3/4.8.2 D.C. SOURCES

BYRON - UNITS 1 & 2

MARKED UP PAGES FOR PROPOSED CHANGES TO

EVALUATION OF SIGNIFICANT HAZARDS CONSIDERATIONS FOR PROPOSED CHANGES TO APPENDIX A TECHNICAL SPECIFICATIONS OF FACILITY OPERATING LICENSES NPF-37 AND NPF-66

TABLE 4.8-2 (AT&T)

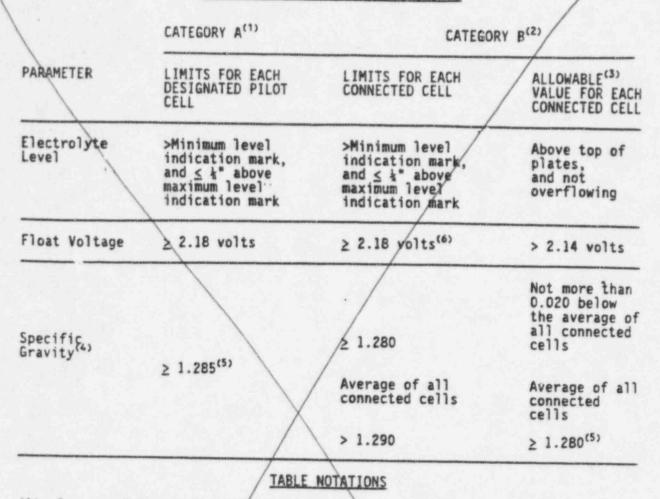
delete page
